Revision C: This document supersedes previous revisions.
Step 4 on page 3 updated as per comments "Remove and discard..." added.

DPF SUPPORT BRACKET P/N 040837 CRACKING ISSUE

Prevost vehicles

FIGURE 1: OVERVIEW OF FINAL INSTALLATION

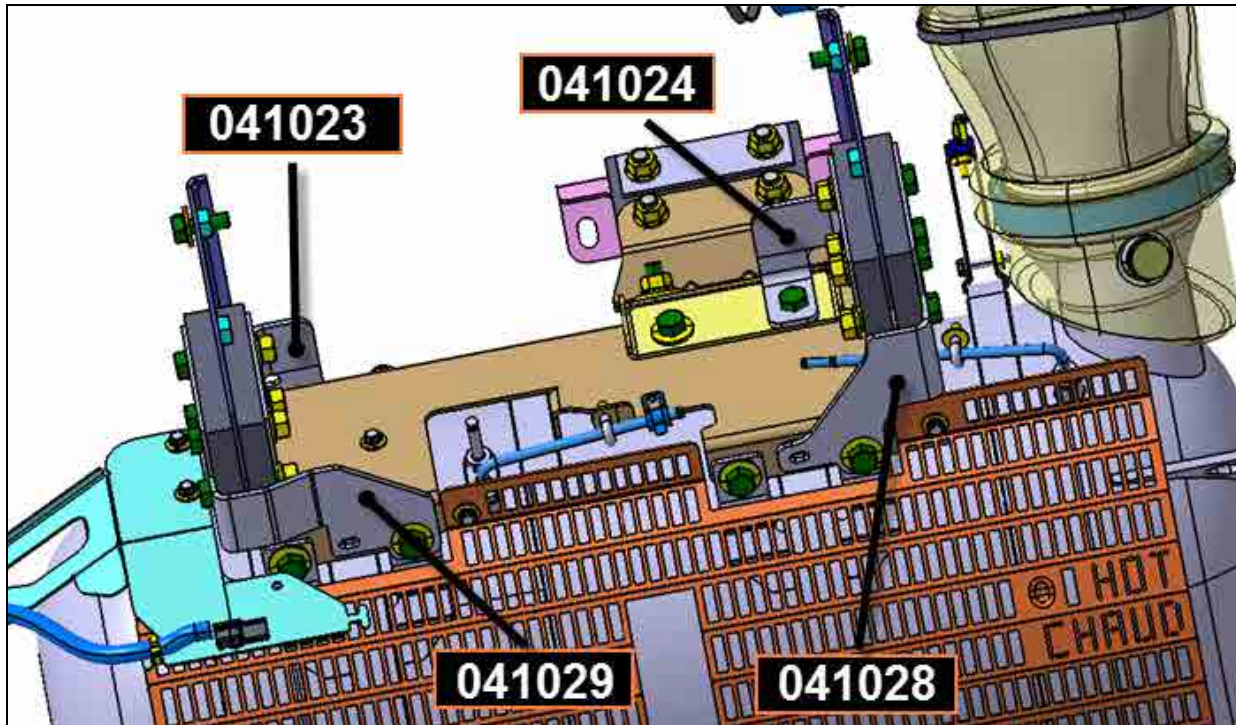
On the vehicles affected by this bulletin, four (4) reinforcement brackets must be added to the DPF support.

1. First, take note that it is very important to install the reinforcement bracket one at a time in order to preserve the present DPF position adjustment.
2. **Torque seal (#685353 or similar) should be applied** once bolts are properly tightened.

FIGURE 2

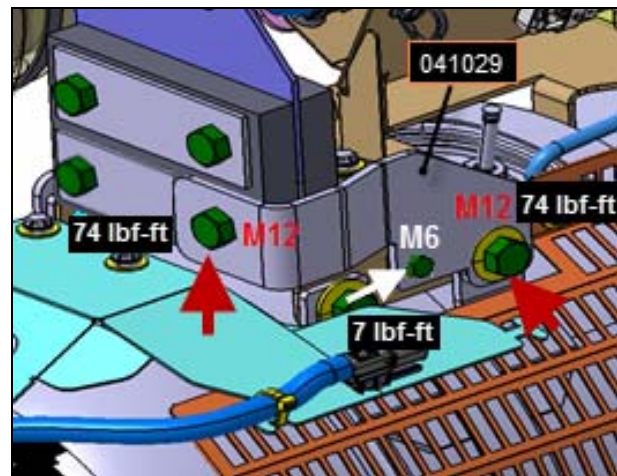
BRACKET 041029

3. The rectangular stainless steel plate shall not be moved and must remain in place, between the rubber pieces and the reinforcement brackets. Having distorted SS plates is normal.
4. Unscrew and remove the three identified bolts in fig.2. Remove and discard the existing bracket.
- 2 x M12 bolts (see red arrow)
- 1 x M6 bolt (see white arrow)
5. Install new reinforcement bracket 041029 (shown in proper location, fig.2), secure using existing M12 bolts (red arrows) and M6 bolt (white arrow) (fig.2).

Torque: M12 bolt (2x): 74 lbf-ft.

M6 bolt (1x): 7 lbf-ft.
